MIDLAND ENERGY CENTER GWO 7020
ADDITIONAL INFORMATION TO JANUARY 4-6, 1984
NRC AUDIT QUESTIONS
File: 0485.16.1 UFI: 42*05*22*04 Serial: CSC-7533
0460.2 12*16
00211(S)

REFERENCE: J A Mooney to J J Harrison letter dated February 8, 1984, CSC-7292

Enclosed find the following three items of additional information to the referenced letter:

Evaluation of Cracking in Slabs at Elevation 674 ft-6 in.,
685 ft-0 in. and 704 ft-0 in.

FIGURE 3 - 21

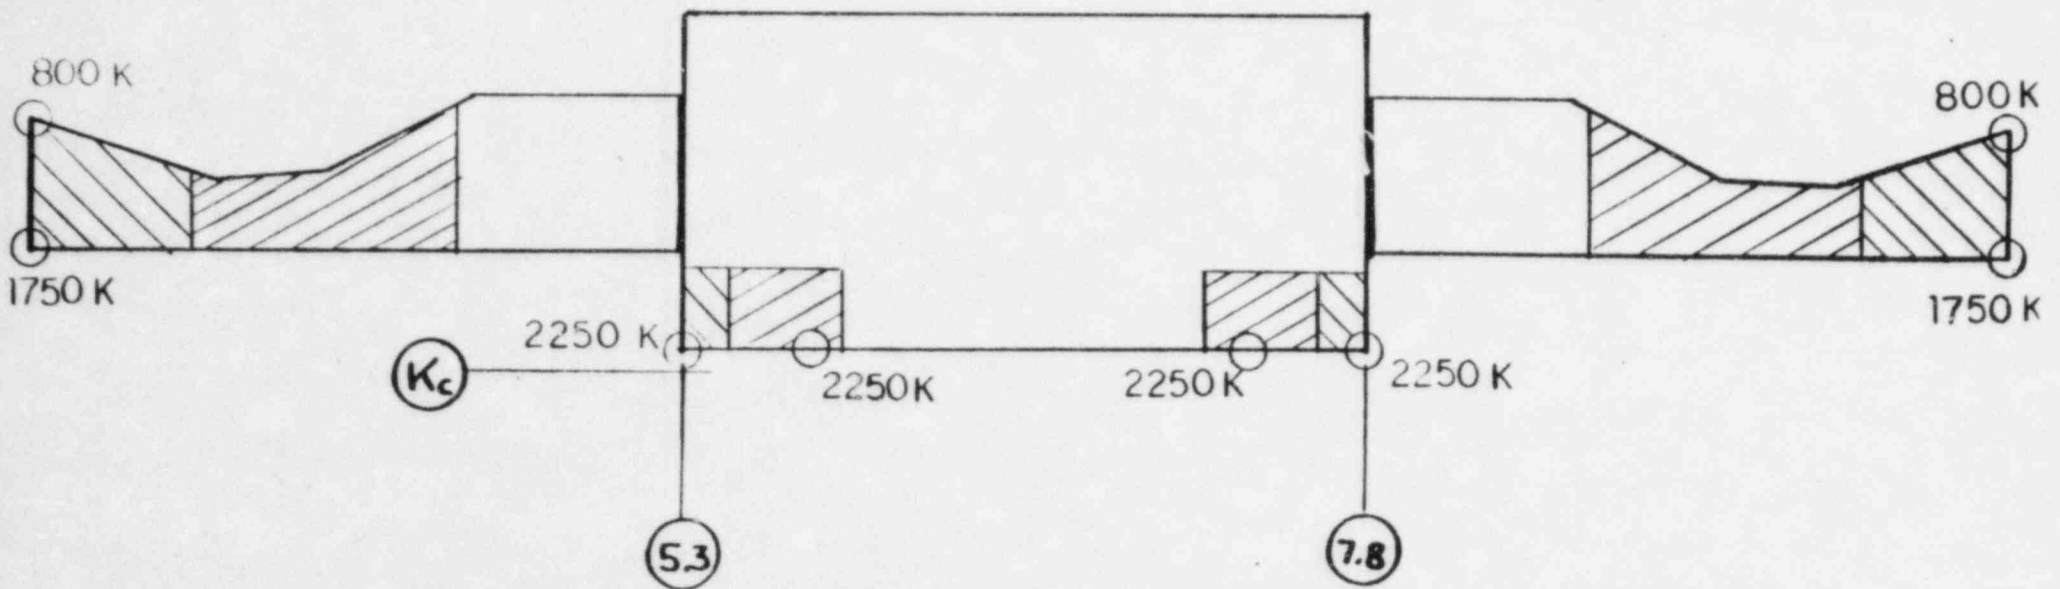
5. Following jacking of CT 1/12 (load combination 5) - Figure 3-5 (see Reference 1, Attachment 3)
6. Following excavation of E/W 5 and CT 3/10
7. Following jacking of CT 3/10 (load combination 7) - Figure 3-21

The stress and strain values for construction stages 7, 8, 10, and 16 have been analyzed. These stages represent the maximum and minimum values of the predicted differential deflections (Δ_1 and Δ_2) for temporary construction stages 6 through 19 as shown in Figures 3-15 through 3-20. The changes in stress and strain values as shown in Tables 3-9 through 3-16 correspond to the changes from the previous construction stages, as included in the table. For example, the change in stress and strain in stage 10 is the change between stage 8 and 10.

FIGURE 3-22

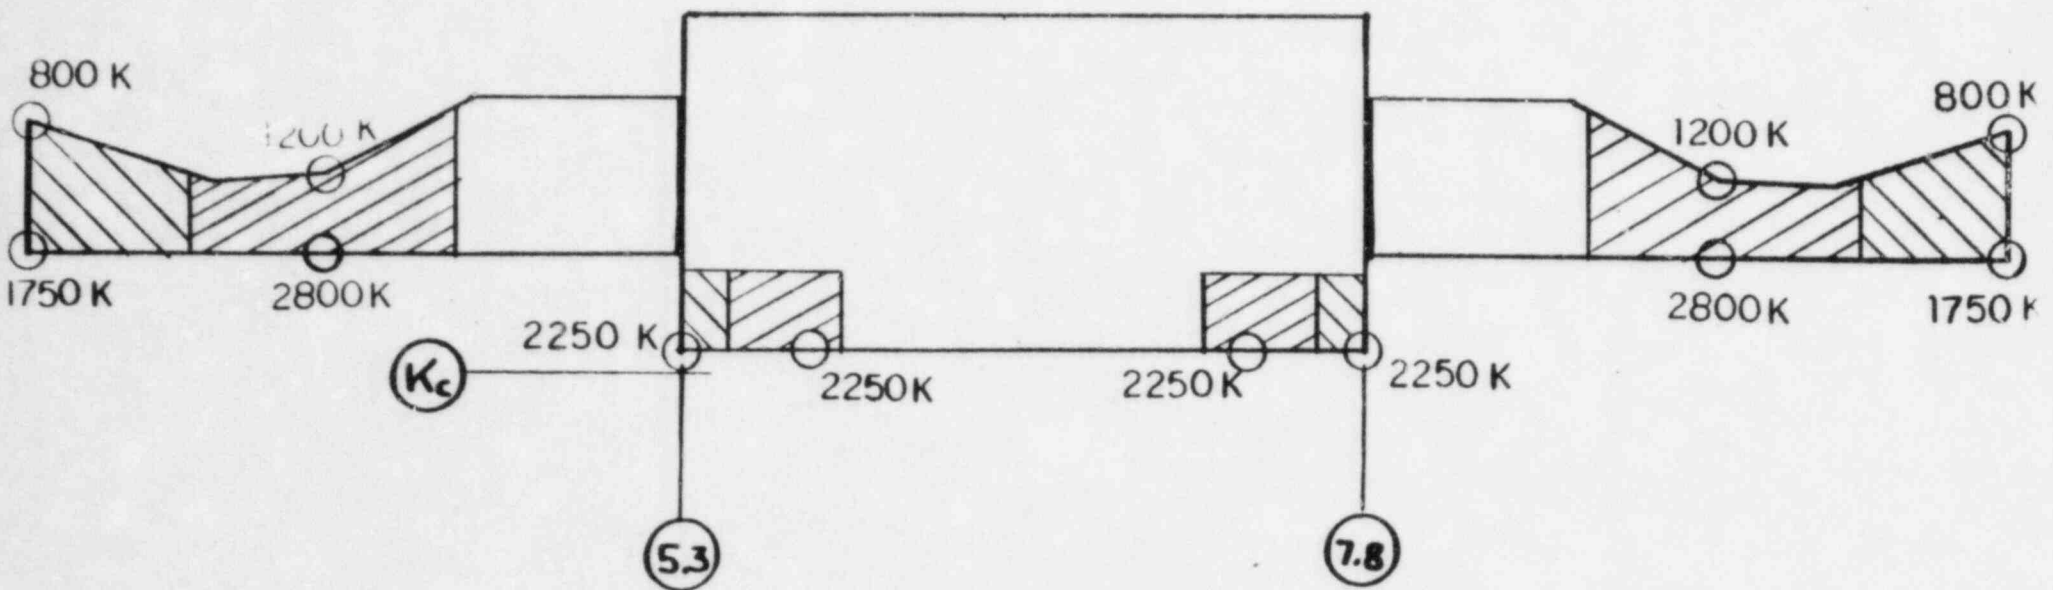
8. Following jacking of E/W 5 (load combination 8) - Figure 3-22
9. Following excavation of CT 5/8
10. Following excavation of E/W 2 (load combination 10) - Figure 3-23

FIGURE 3 - 24

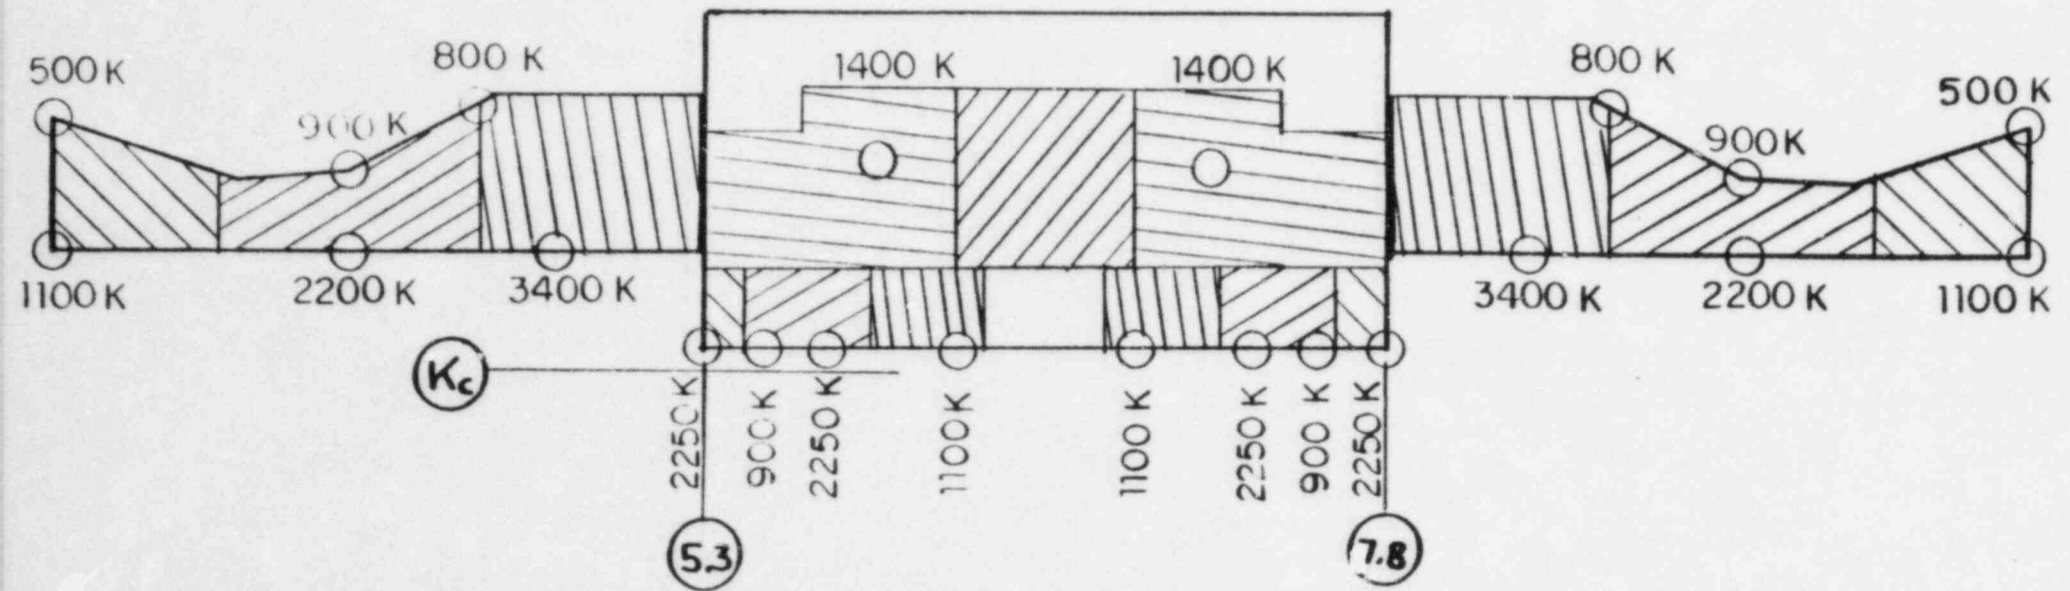
16. Following jacking of E/W 2 (load combination 16) - Figure 3-24
17. Following jacking of CT 14
18. Following excavation of balance of soil
19. Following jacking of CT 6/7

Fig. 1 Plan of Structural Steel Framing
at Elevation 685 ft-0 in.

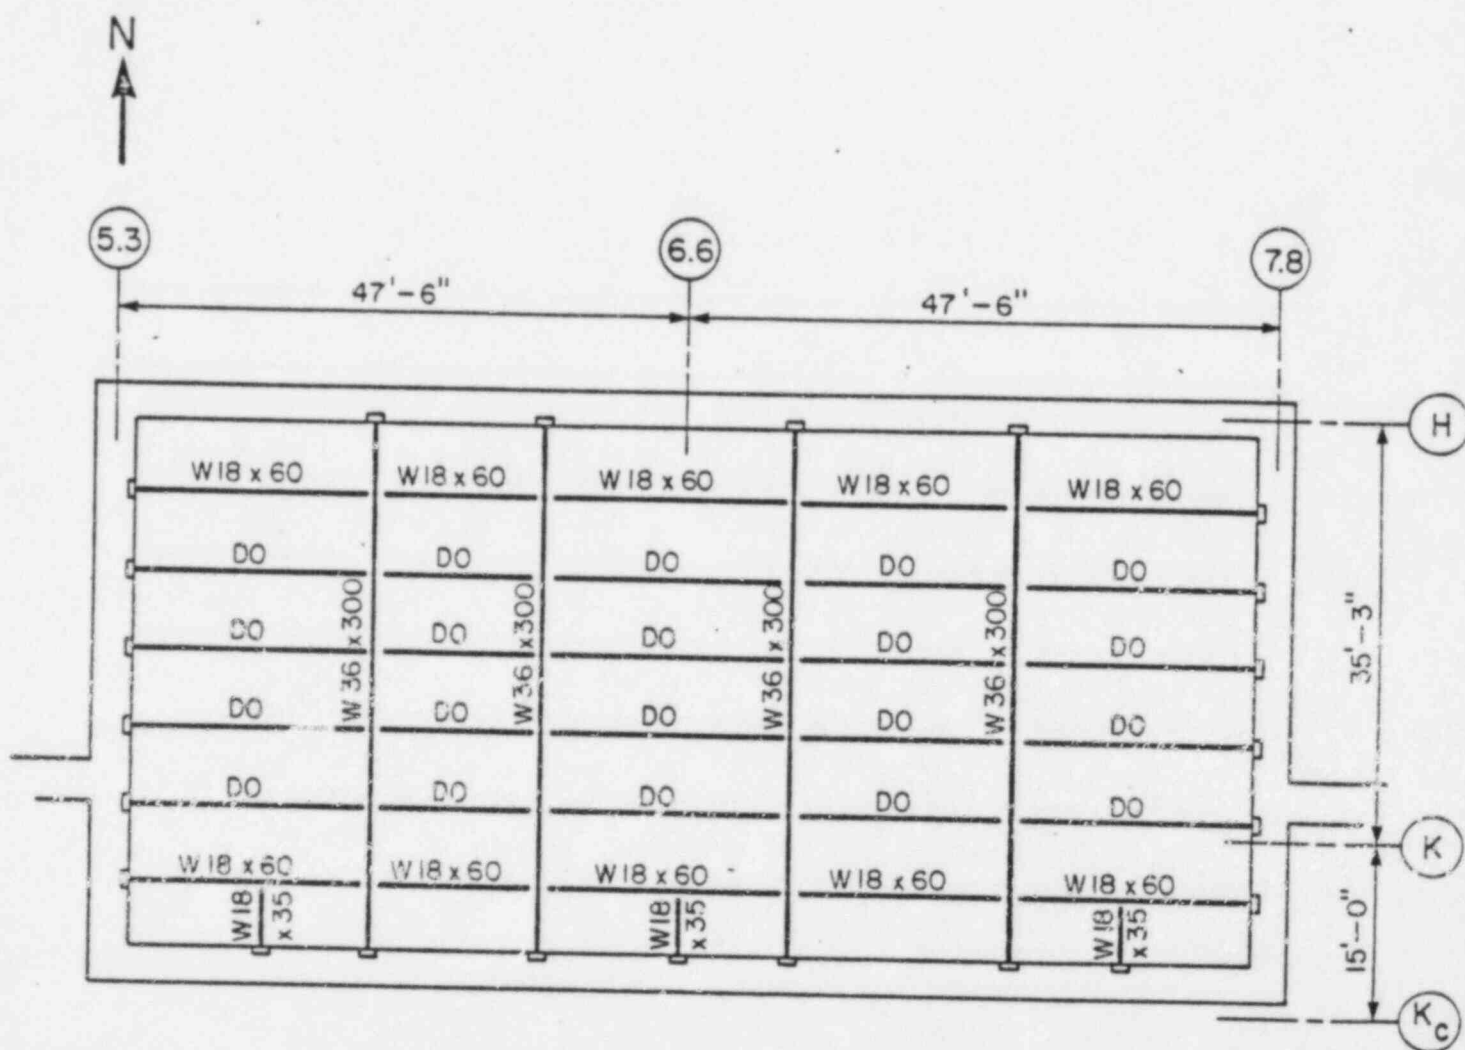
Slabs in the Control Tower are restrained from shrinkage in the plane of the slab by internal reinforcement, by the steel framing system under the slabs and by the surrounding walls. As shown in Fig. 1 and 2, for Elevation 685 ft-0 in., shrinkage movement in the east-west direction is restrained by two layers of No. 6 bars at 18 in. on center and by six W18x60 steel beams spaced at approximately 6 ft-6 in. The beams are continuously connected between the north-south walls from Column Line 5.3 to 7.8. The internal reinforcement and external beams are constraints that contribute to the potential for the observed cracks in the north-south direction.

As shown in Figs. 1 and 2, the slab at Elevation 685 ft-0 in. is restrained in the east-west direction by two layers of No. 6 bars at 18 in. on center and by six W18x60 steel beams spaced at approximately 6 ft-6 in. As shown in Fig. 5, the west bay of the floor at Elevation 674 ft-6 in. contains only two W21x82 beams connected to the west wall along Column Line 5.3. The beams are located relatively close to the east-west walls at Column Lines H and K_C. There is no continuously connected restraint within the center 30-ft wide region between the north-south walls from Column Line 5.3 to 7.8. Figure 6 shows that shrinkage in the east-west direction is also restrained by two layers of No. 6 bars at 12 in. on center.

Fig. 2 Internal Reinforcement, Openings and Concrete Information for Slab at Elevation 685 ft-0 in.

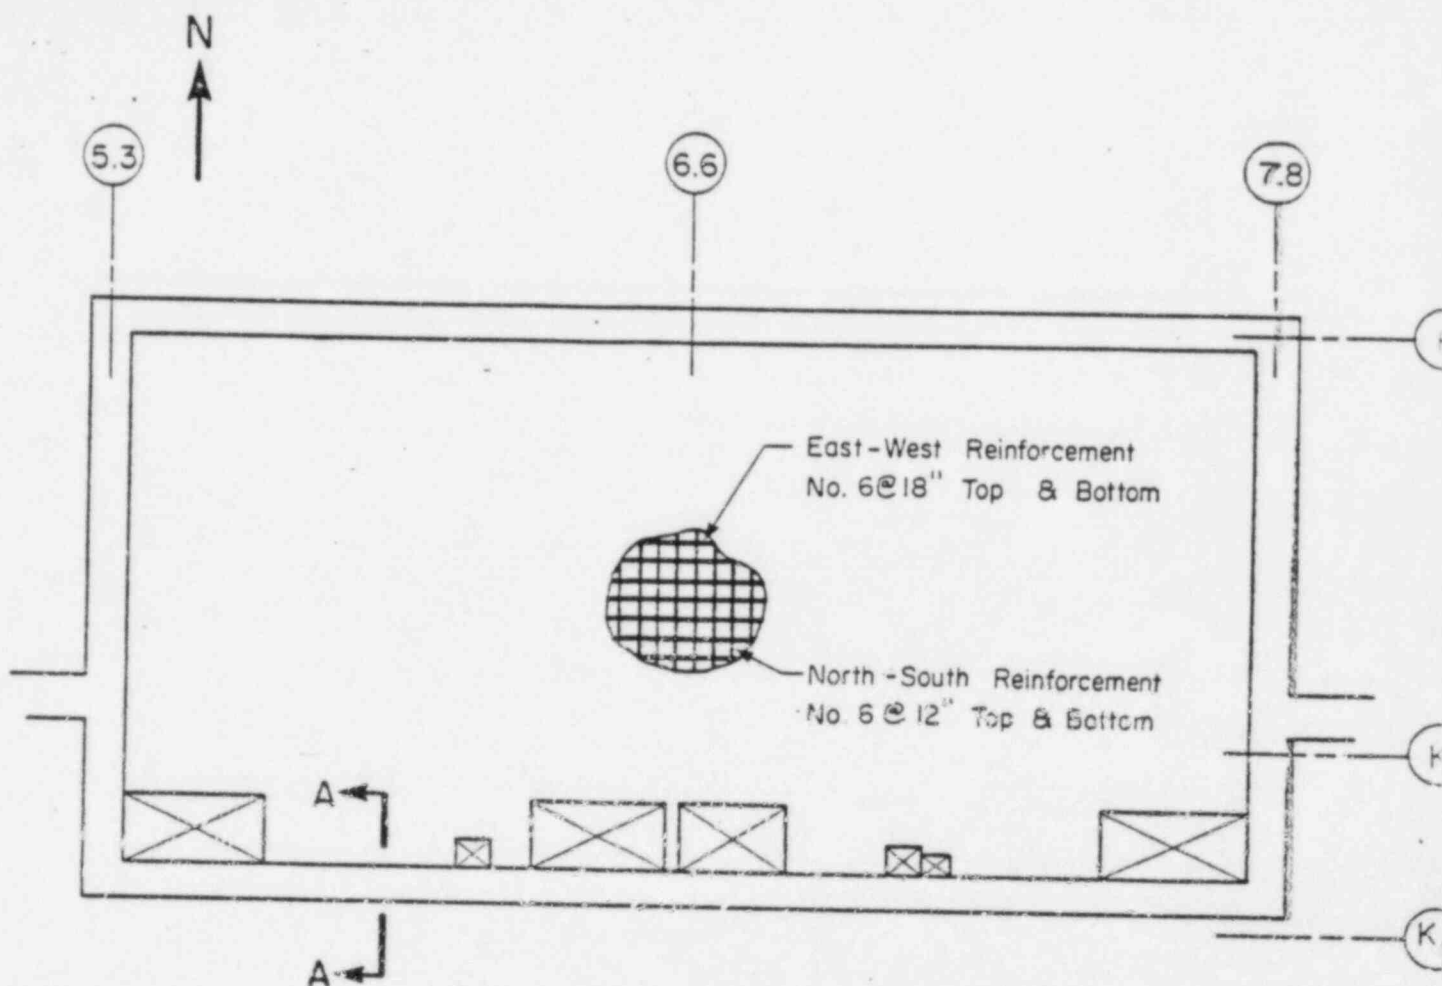
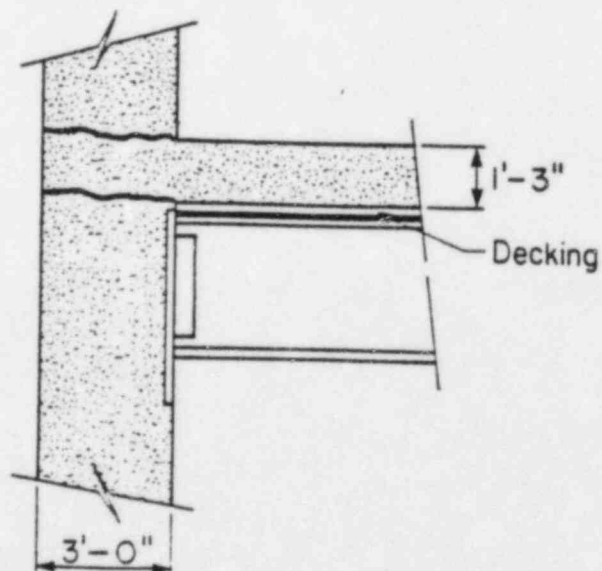
As shown in Section A of Fig. 4, the roof slab is restrained by walls that support the edge of the slab from below. However, Section A in Fig. 2 shows that the slab at Elevation 685 ft-0 in. is restrained by walls that extend above the slab in addition to walls that support the edge of slab from below. The edge restraint on the slab at Elevation 685 ft-0 in. is essentially
